DAUPHIN COUNTY SUBDIVISION/LAND DEVELOPMENT REVIEW REPORT

Plat Title: 421 Million Dollar Road

Project Description: Lot addition and creation of 1 new building lot

MINOR FINAL SUBDIVISION PLAN
OF
421 MILLION DOLLAR ROAD
AND
PARCEL 29-024-015

1 of 2 - COVER SHEET
2 of 2 - SUBDIVISION PLAN

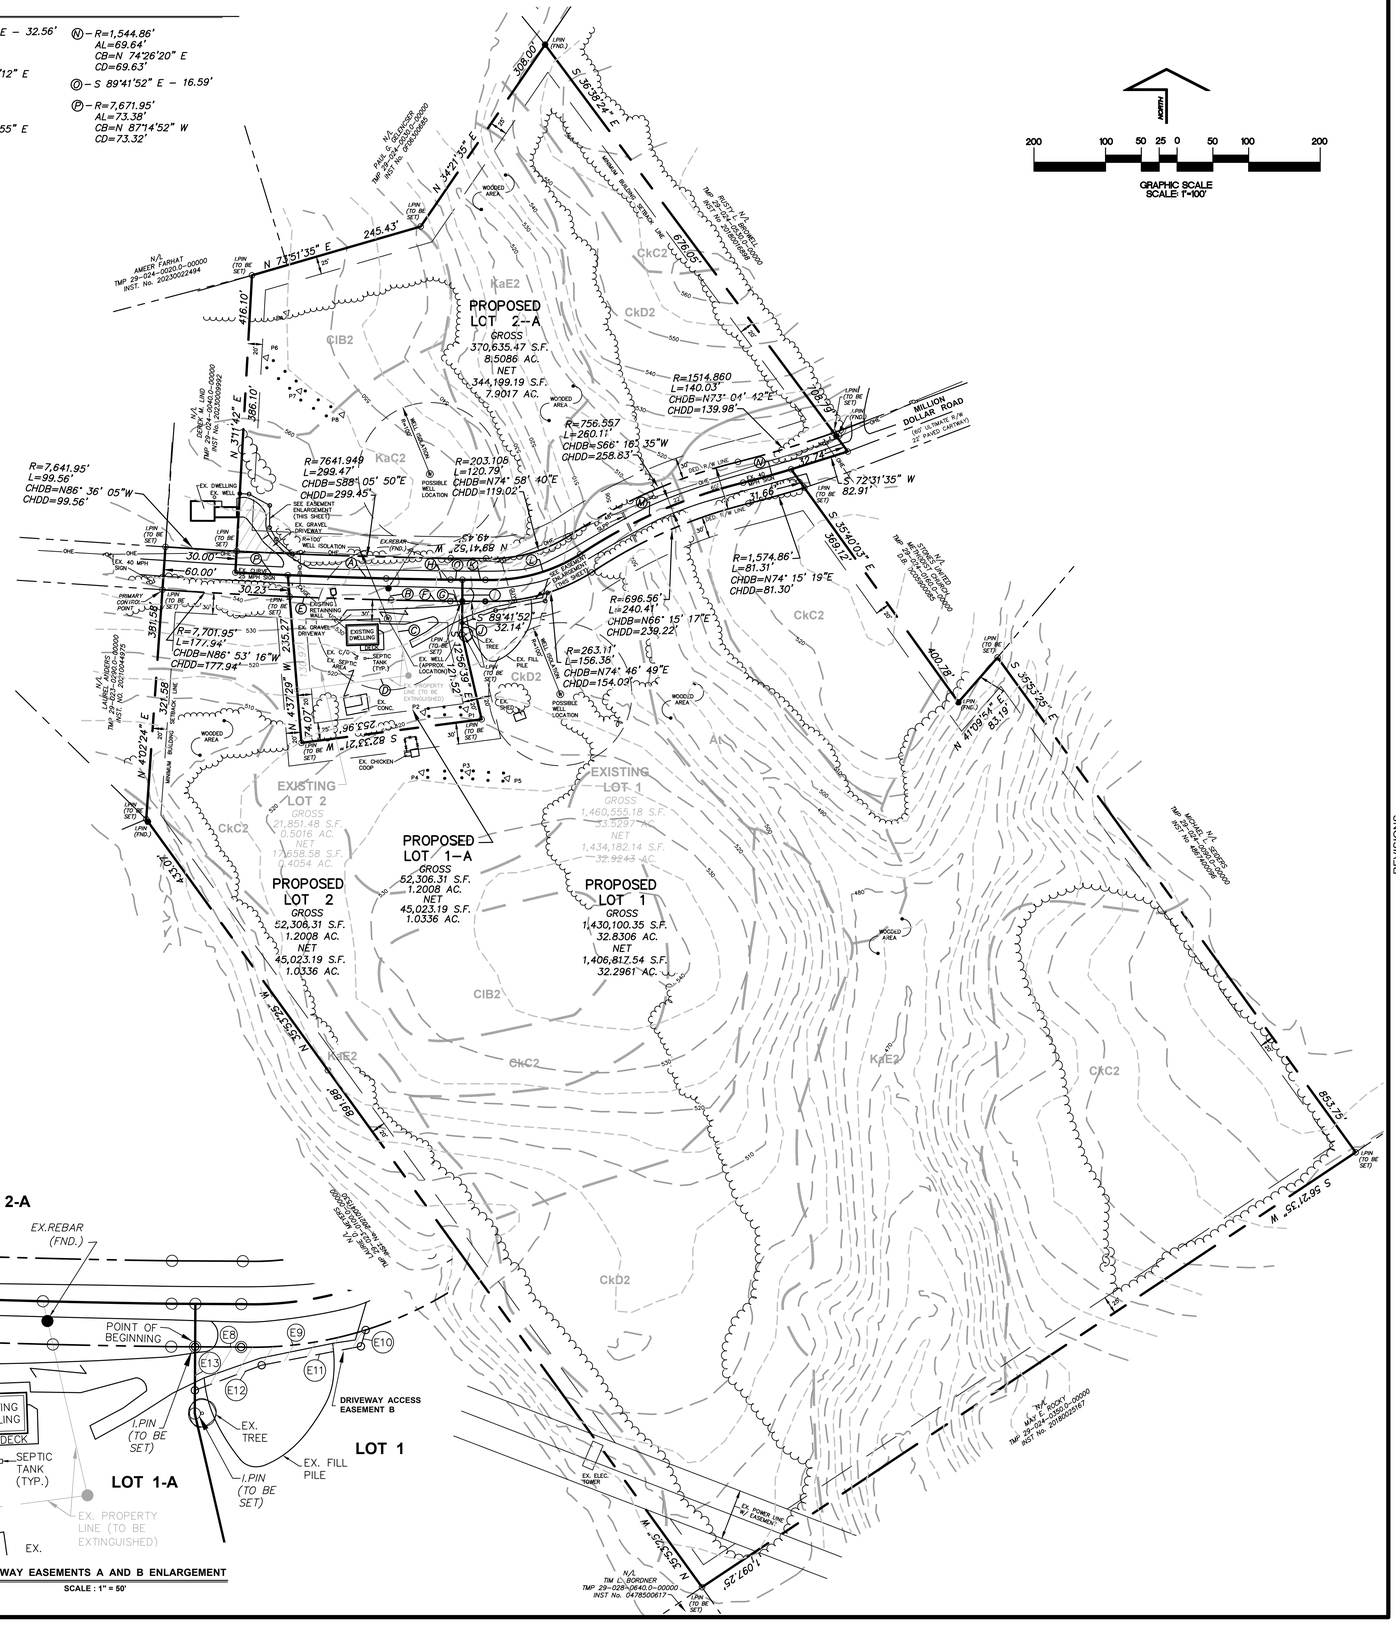
3. All watercourses are required to be displayed on the plan (S-LD § 405.1.a.xii per 407.1.a) There appears to be a stream that runs north/south through the center of Existing Lot 1 on both the north and south side of Million Dollar Road.

4. Any existing and proposed easements are required to be displayed on the plan for reference (S-LD § 405.1.a.ix per 407.1.a) – This includes any existing utilities (underground or overhead) and drainage easements along any watercourses.

5. Drainage easements shall be at least 30' in width. (S-LD § 503.3)
6. Contour intervals of 2 feet are required to be displayed. (S-LD § 407.1.a.vii) The plan shows the applicant's intent to request a modification of this requirement.

11. Monuments and markers shall be set in accordance with S-LD § 602.
12. Lot area tabulation should be verified for accuracy. According to Dauphin County Parcel Viewer, Existing Lot 1 should be 42.20 acres, while the plan shows 33.5297 acres. It appears the 8.5086 acres of Proposed Lot 2-A were not incorporated in the calculation for Existing Lot 1. Proposed Lot 2 and Proposed Lot 1-A show the same area calculation. Since Proposed Lot 1-A is the lot addition, only the area of the lot addition should be shown for this. Proposed Lot 2 should be the area of Existing Lot 2 plus the area of Proposed Lot 1-A (lot addition).

14. If the location of the proposed dwelling unit is known at this time, it could be displayed on the plan for reference.
